Planning Application P/16/121

Resubmission of an application for a proposed rear three storey extension to Roanoke, and changes to the front elevation.

Estimated effect of east facing wall on morning light for 11 Porthcressa Road

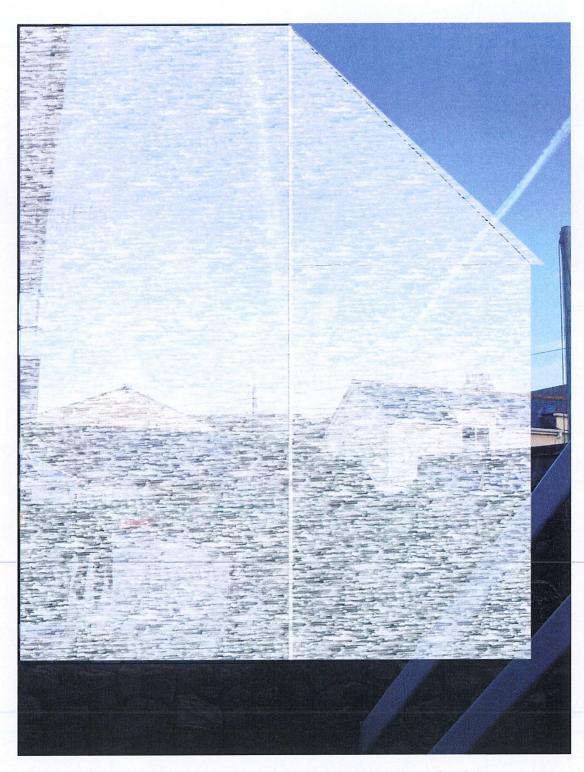
- A severe loss of sunlight to my mother's rear garden, kitchen and bedroom (see attached estimated effect), even in midsummer when the sun sets further to the north;
- The loss of sunlight at the end of the day to my mother's lounge, due to the Juliet balcony at the front of the building which appears to be larger than one would expect;
- the loss of residential amenity due to overshadowing to the rear;

- the loss of outlook to my mother, given the large blank wall that is proposed to extend halfway along the extent of her boundary;
- the adverse effect on the residential amenity to varying degrees of other neighbours;
- the overbearing, out of scale size and overdevelopment of the site with substantial loss of garden land;
